TCEQ DOCKET NO. 2024-1115-EAQ
WPAP PERMIT ID NO. 13001906

In the Matter of the Edwards Aquifer Water Pollution Abatement Plan
By Vulcan Construction Materials, LLC
Before the Texas Commission on Environmental Quality (TCEQ)

MILANN and PRUDENCE GUCKIAN'S
RESPONSE to

TCEQ Executive Director (ED), Office of Public Interest Counsel (OPIC), and Vulcan Construction Materials, LLC (Vulcan) REPLY BRIEFS on Motions to Overturn.

Figure 7. Geologic cross section showing the correlation between the well on the Vulcan site and caves in the same geologic units (Source: J. M. Olivier).

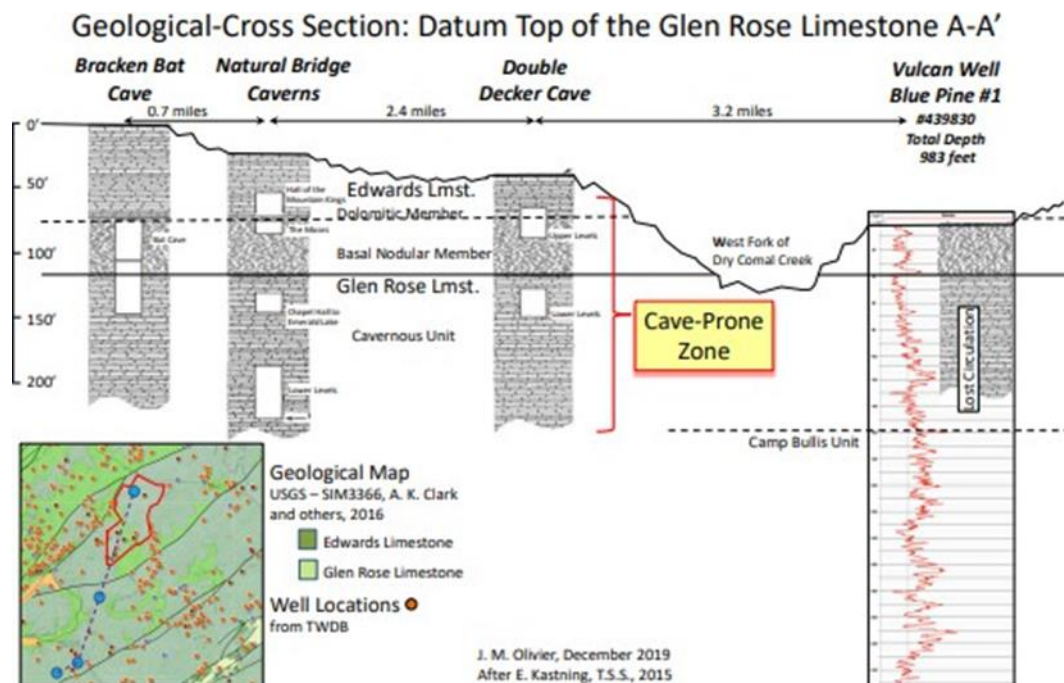
communication, April 12, 2024; Schindel, 2021). As mentioned above, the hydrogeology of the proposed quarry site is similar to that along strike to the northeast and southwest. Water recharging the subsurface will pass through a series of voids that have been formed by dissolution of the limestone, dolomite, and evaporite lithologies. These solution voids are more concentrated along faults and fractures, but interconnected voids can also develop in the absence of faults and fractures. The hydrostratigraphic column in Figure 5 shows that the uppermost hydrostratigraphic unit is called the Cavernous unit because of the large number of caves and smaller voids found in this region (Clark et al., 2023). Plans for the proposed quarrying operation indicate that the Cavernous unit will be significantly mined. A zone of high permeability was encountered in the Vulcan's Blue Pine Holdings #1 well between a depth of 63 and 143 ft. Circulation of drilling fluids and groundwater was lost into the formation over this interval (TWDB Submitted Drilling Reports). This zone of high permeability is correlative to the Cavernous zone and to major caves to the south such as Natural Bridge Caverns (Woodrud et al., 2017). It should be expected that as the quarry advances downward more voids (recharge features) will be encountered. With removal of surface material and the underlying bedrock, it is likely that the area will become more prone to infiltration of surface water and this infiltrating water will be heading directly toward the underlying aquifer. The proposed depth on the mining pits will put them in or near this permeable zone shown by the stratigraphic cross-section below (Figure 7) (J. M. Olivier, personal communication, April 4, 2024).

Figure 8. Potentiometric surface map showing approximate Edwards groundwater flow direction in south-central Comal County to be to the southeast (Johnson et al., 2006).

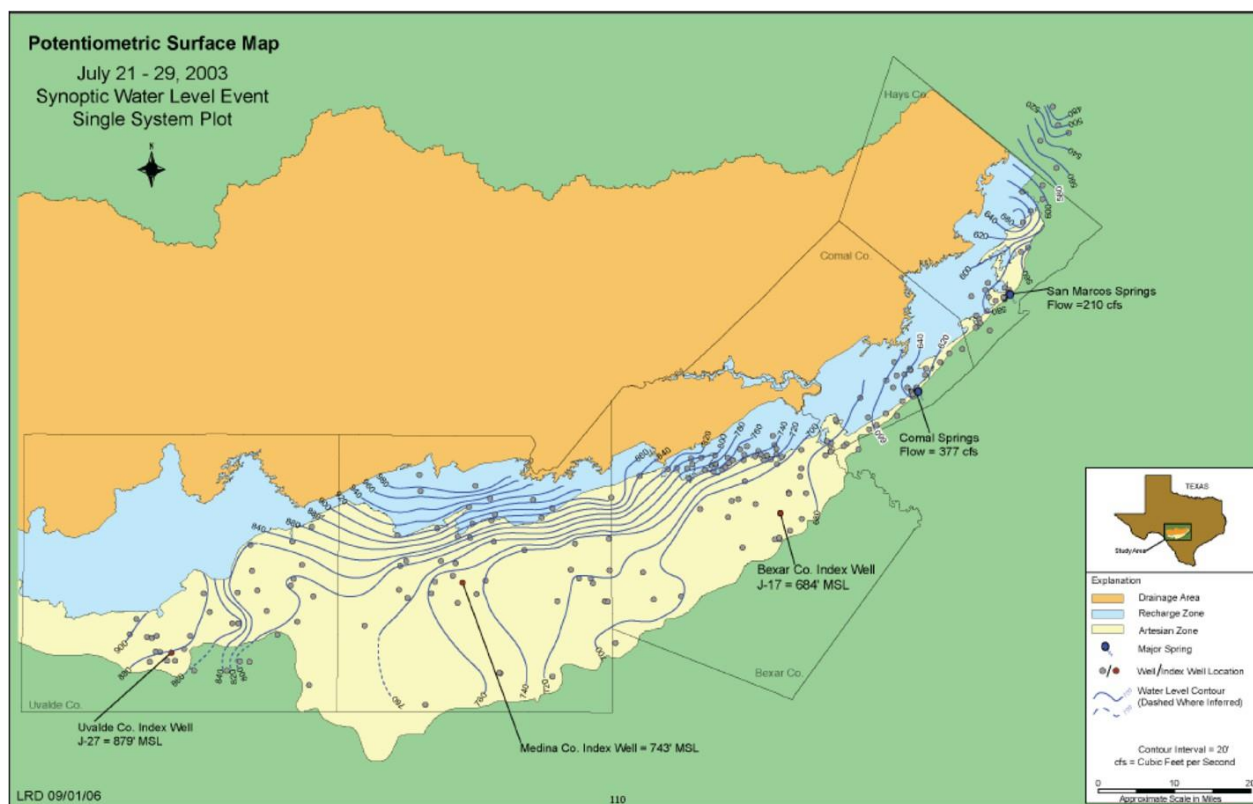
Figure 8 is a potentiometric surface map of the Edwards Aquifer with water-level data from 2003 (Johnson et al., 2006). Even though no data were collected close to the proposed quarry site, the map suggests that flow from the site would move generally southeast then shift to the east then northeast toward Hueco and Comal Springs. A study following a 2,000-gallon diesel fuel spill in January 2000 at the DynoNobel explosives plant near the CEMEX Balcones Quarry in New Braunfels, Texas, shows flowpaths of the diesel fuel to both Hueco and Comal Springs (G. Schindel, personal communication, April 12, 2024). The proposed Vulcan quarry site is located seven miles NW from the plant. Groundwater flowing from the site would flow generally southeast until it reaches these flowpaths and would ultimately discharge to Hueco and Comal Springs. Some lesser components of the flow would bypass the springs and flow further downgradient towards San Marcos Springs.

Figure 9. Schematic cross section with estimated topography after mining and water levels based on available data (J. Finneran, personal communication, April 16, 2024).

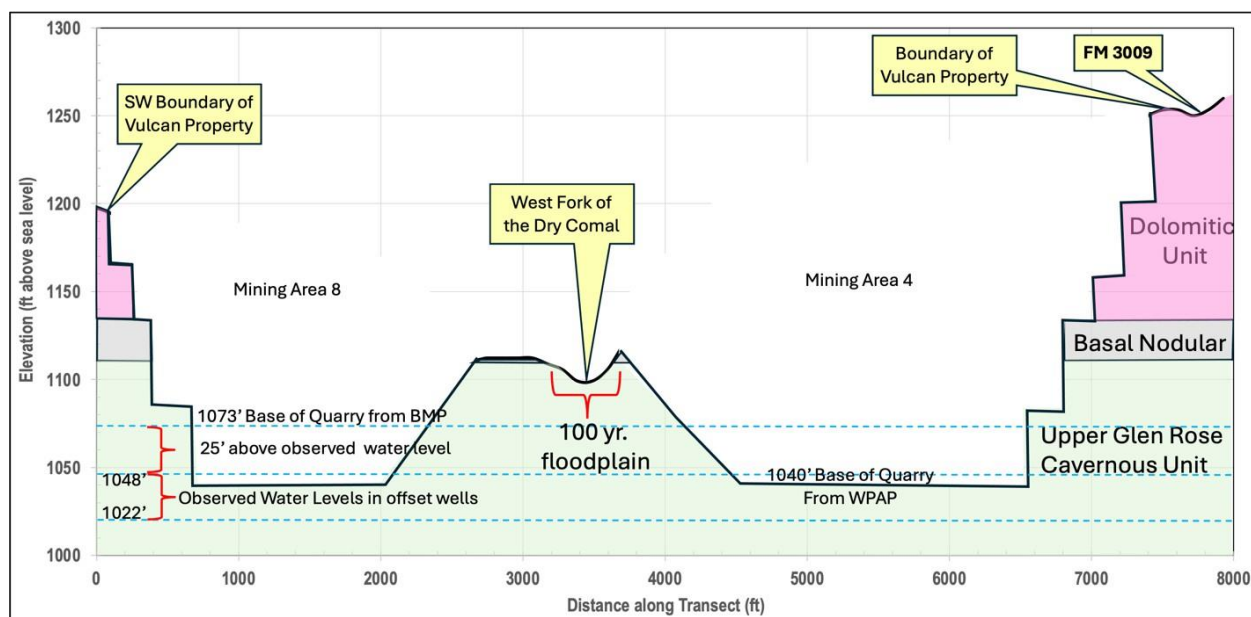
The WPAP (Pape-Dawson Engineers, 2024) for the site states that the mining areas will not be mined below an elevation of 1040 ft msl. According to the WPAP, this level of the quarry bottom will provide a 25-ft bufer above the high water level of the aquifer. A review of available water-level data indicates that at times, the bottom of the quarry will be flooded by the underlying aquifer (Figure 9). Water-level data from five wells close to the perimeter of the quarry boundary were evaluated to estimate expected water levels beneath the quarry and proposed depths of the excavations (Appendix B) (J. Finneran, personal communication, April 16, 2024). The White #4 well (#520690) had a water level of 1022 ft-msl on 12/5/07. At this water level plus the 25-ft bufer, the bottom of the quarry would be out of compliance. Another well (Tucker, EAA #Wxxx-137) had a water level of 1048 ft on 12/14/98. At this water level, the bottom of the quarry would be 8 ft below the water level in the aquifer.

- Elevations of the aquifer should be determined prior to any excavation. The elevation of 1040 ft-msl for the bottom of the quarry, as stated in the WPAP, is likely to be out of compliance with the required buffer of 25 ft. And it is also likely that water levels in the aquifer will be above the elevation of 1040 ft-msl during periods of high water levels.
